JUNIPER 11-254
ENERGY STAR

TOWN OF MILTON
PLANNING AND DEVELOPMENT
BUILDING PERMIT: 17-6230

Greenpark
PROJECT NAME: LECCO RIDGE

SHEET TITLE
BASEMENT PLAN ELEV. 2

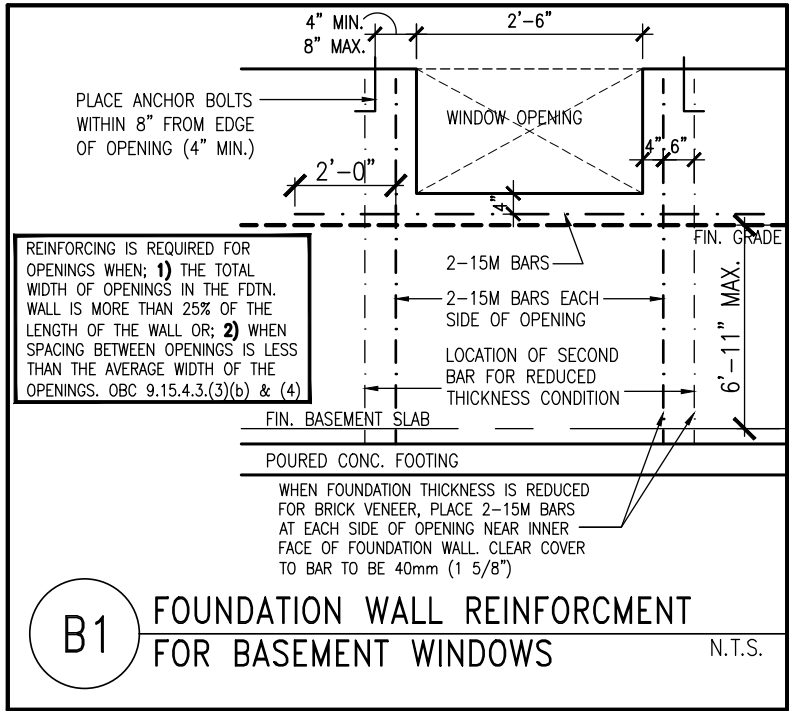
UNSUPPORTED FOUNDATION
Foundation wall laterally unsupported below window open. Provide reinforcement as specified in detail B1
